ADDENDUM #1
TUNNEL MANHOLE
REHABILITATION F/Y 24-1
CONTRACT #2024-22
REGIONAL WATER RESOURCE AGENCY

DATE: October 28, 2024

MH #789

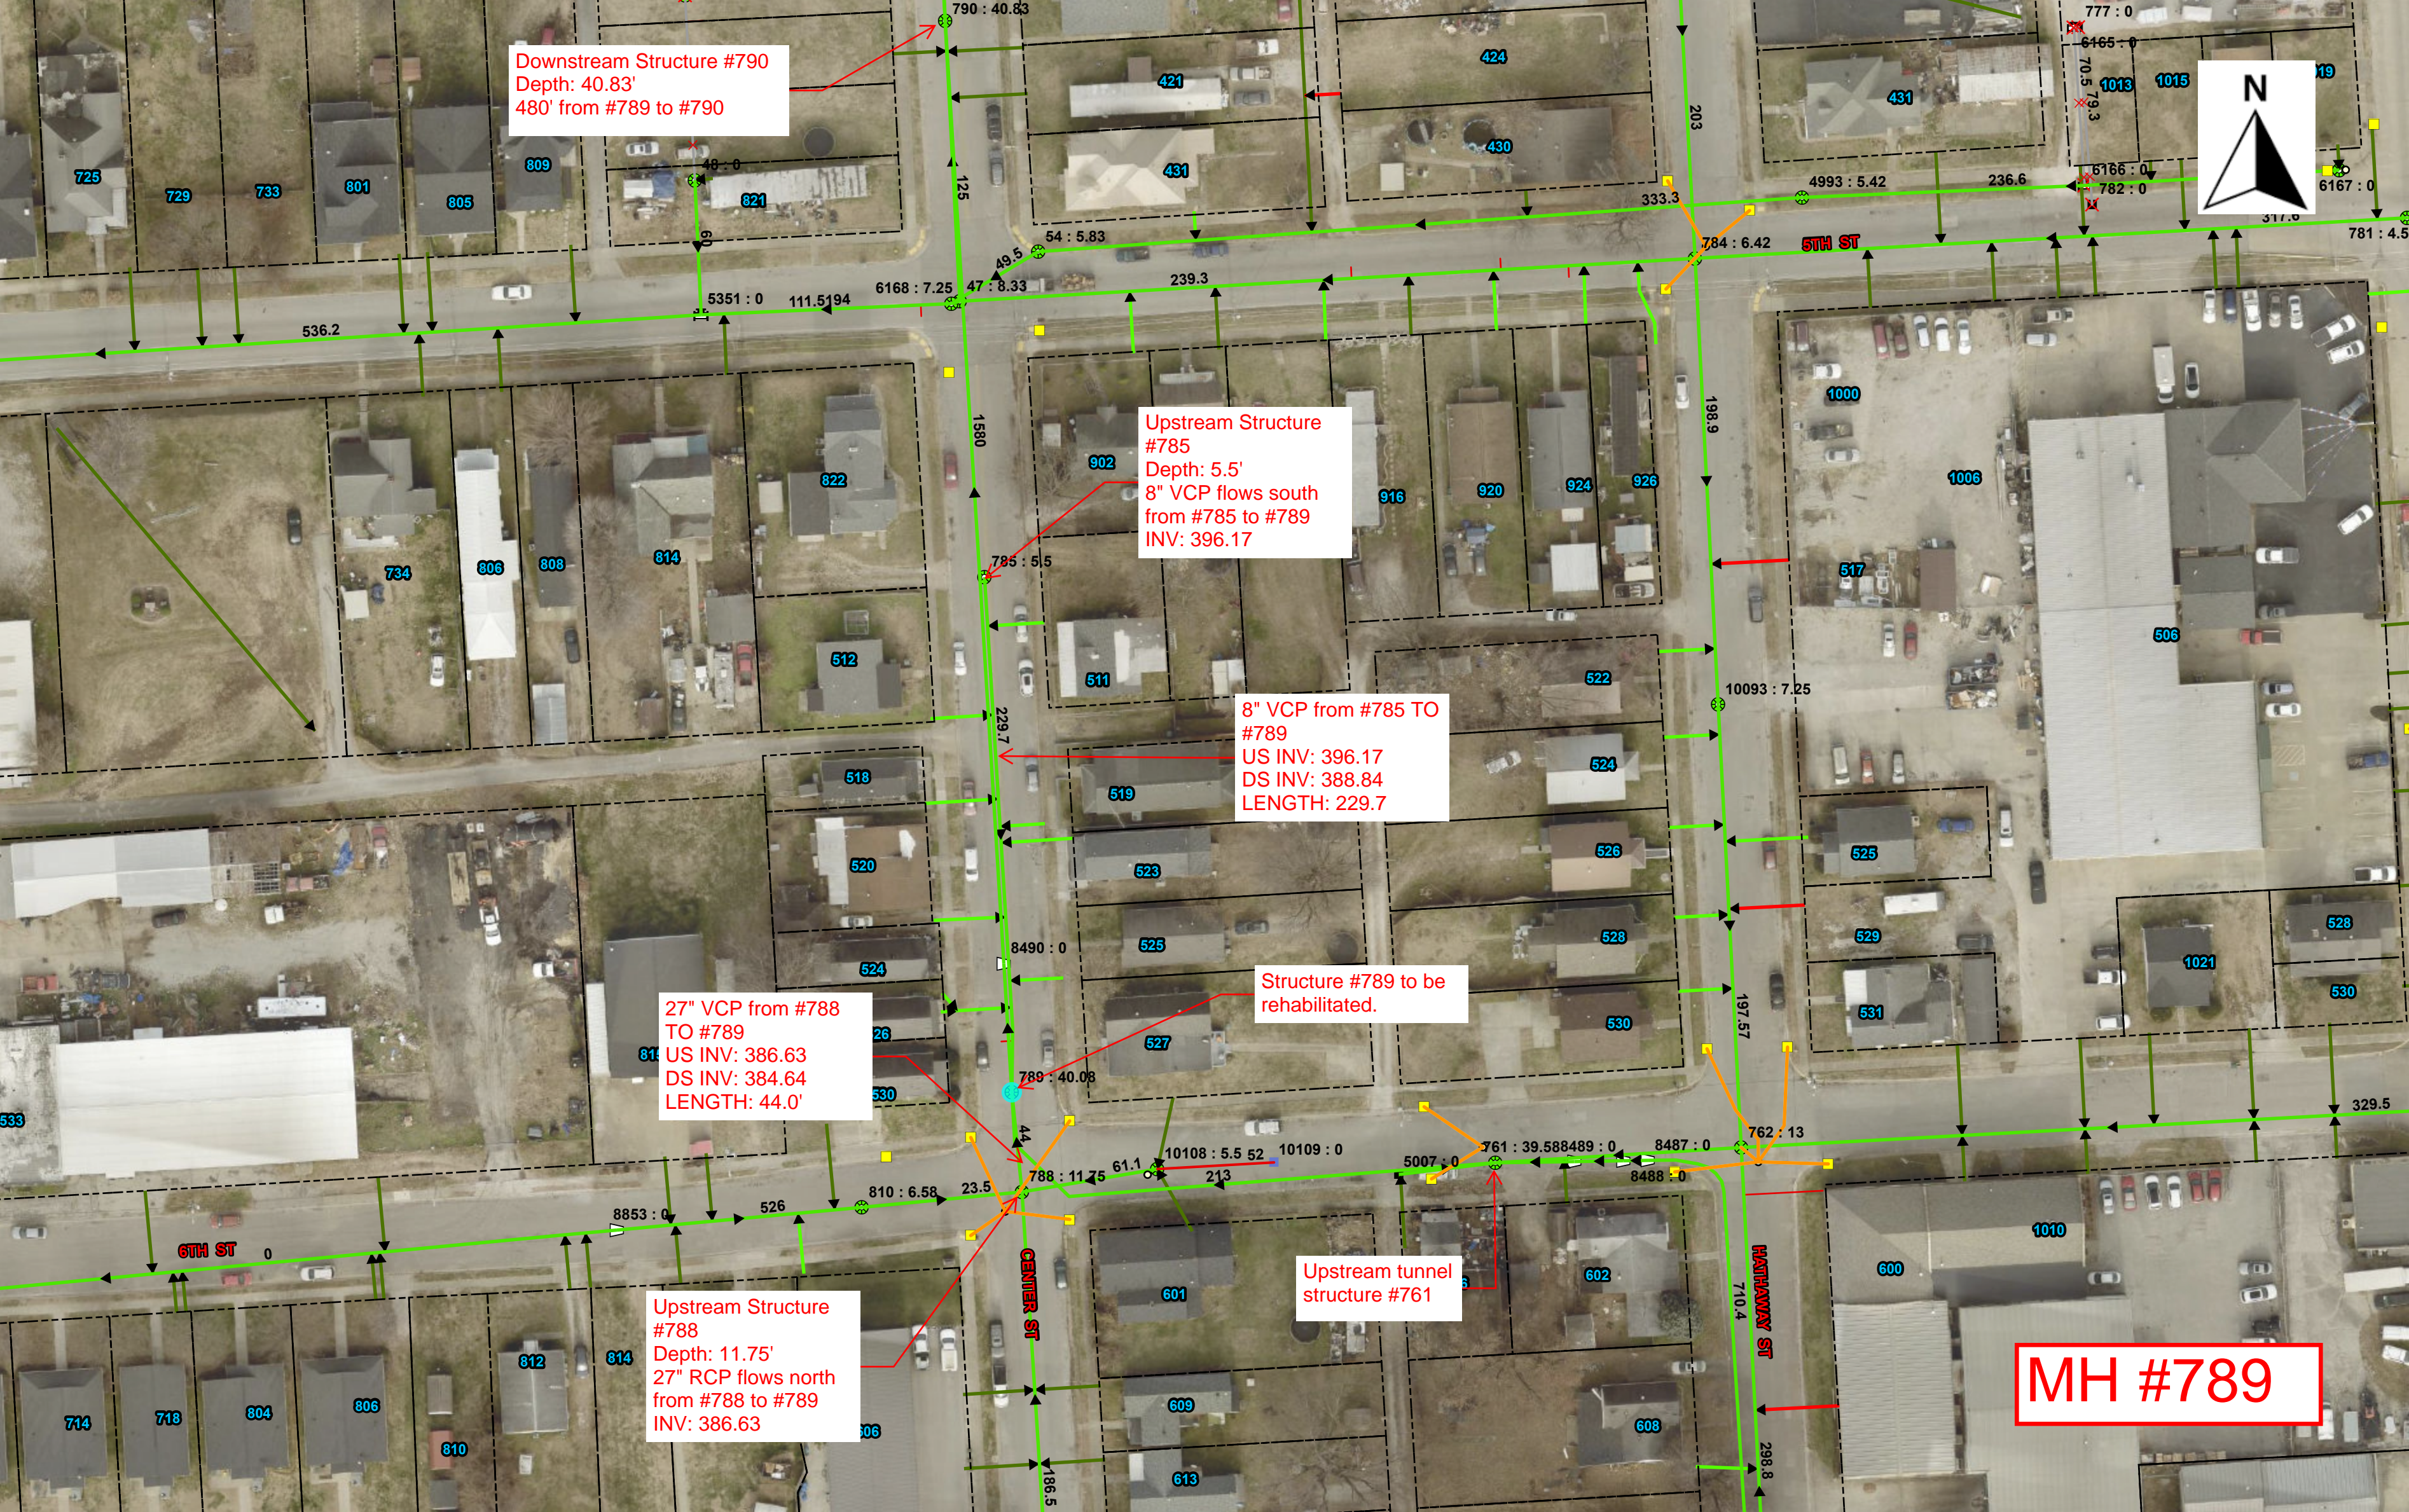
5. **Can RWRA provide more information regarding the system around the work structures to assist in developing bypass plans?**

6. **Can RWRA provide slopes of the pipes to be bypassed?**

- 16. Is there any way of picking up the flow up stream to prevent the need to have bypassing internally?**

RWRA has created a new set of maps for each structure that includes upstream and down stream tunnel structures, as well as depths, lengths, slopes, etc. of incoming pipes. These maps are included as an appendix to this Addendum #1. All information provided on these maps are for reference purposes only. Contractor shall verify all information.

Structure #789 to be rehabilitated.

27" VCP from #788 TO #789
US INV: 386.63
DS INV: 384.64
LENGTH: 44.0'

Upstream Structure #788
Depth: 11.75'
27" RCP flows north
from #788 to #789
INV: 386.63

DR.	CSK	SCALE	1"=1'-0"	TITLE:	R-1741-D
CH.		DIM CHK.			FRAME WITH DOUBLE LIDS
APP.				NEENAH FOUNDRY COMPANY	NF-1741 600 B
DATE	REVISION	DATE	10-19-1993	NEENAH WISCONSIN 54956

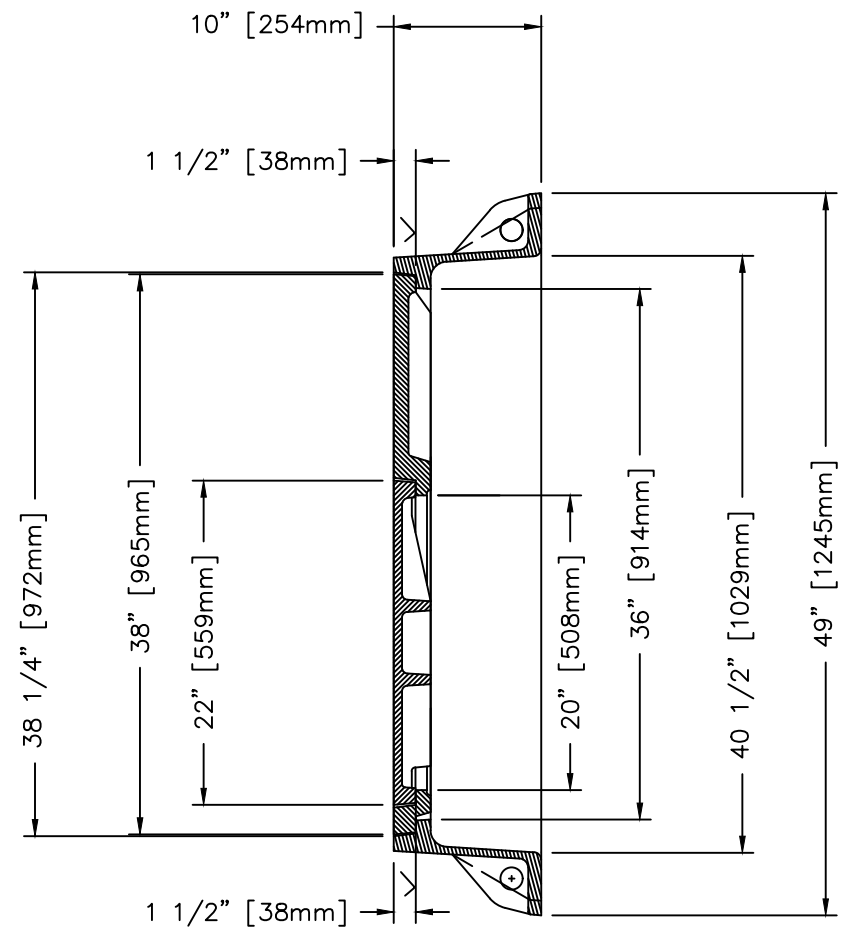
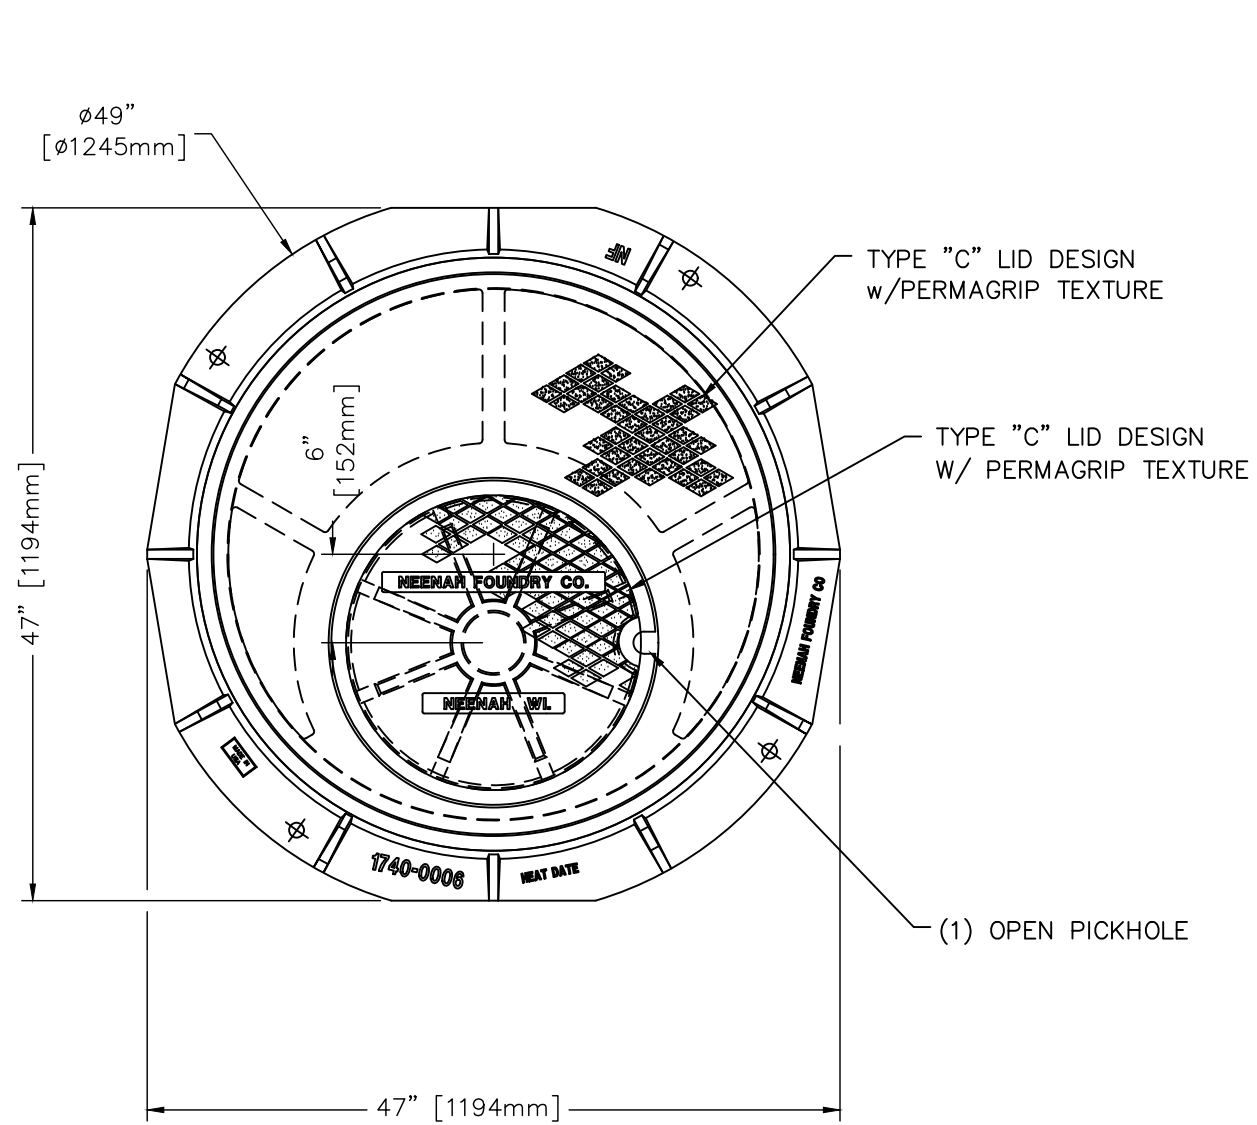
- 17. Casting access, what are the clear opening dimensions of the new frame being installed? The bigger the better in this scenario.**

If Contractor considers installing a larger diameter manhole frame to assist in work access, Contractor may submit alternate plan for review and approval by RWRA. An example of a larger diameter manhole frame that RWRA currently utilizes is included in the appendix of this Addendum. Contractor still responsible for having precast manufacturer/Engineer approve changes to precast cap structure. Contractor responsible for material, work and any other costs associated with changes to manhole cap, frame and lid.
